Service Bulletin

Category S	Applicable Model/s 1994-97 MX-5 Miata	Subject THUMPING OR POPPING NOISE FROM FUEL TANK AREA	Bulletin No. 017/97 Issued 07/16/97 Revised
---------------	---	---	---

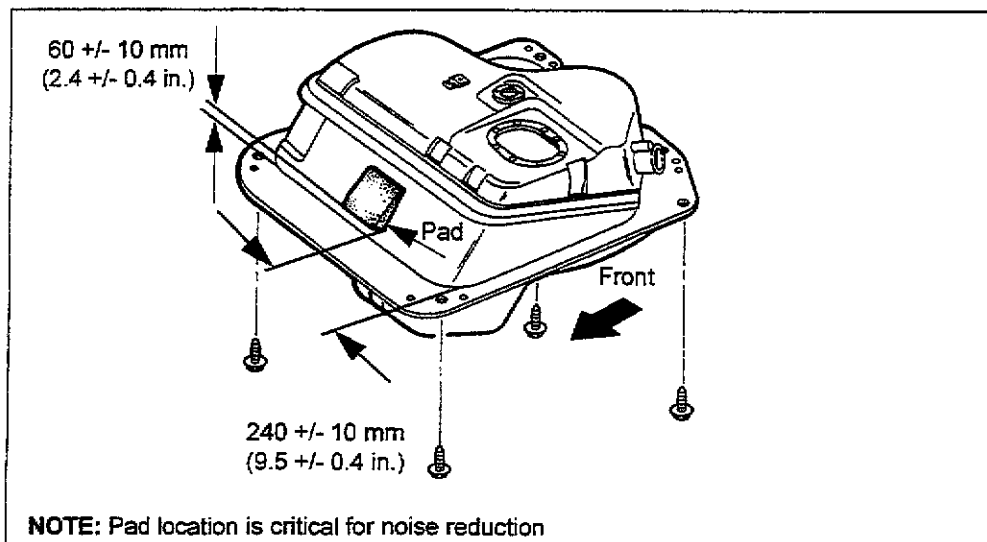
The noise is caused by a slight torsion of the fuel tank and a change in temperature. A pad has been added to the fuel tank upper pan to reduce noise. Customers complaining of this noise should have the vehicle inspected and if necessary have a pad installed according to the procedure below.

1. Allow time for the exhaust system to cool.
2. Loosen the four bolts holding the fuel tank in place.

3. Clean the pad installation area (above driveshaft).

4. Add pad to the position indicated in the illustration below.
5. Re-tighten the fuel tank installation bolts to the correct torque, 21-30 Nm (2.1-3.1 kgf.m, 16-22 ft.lbs.)
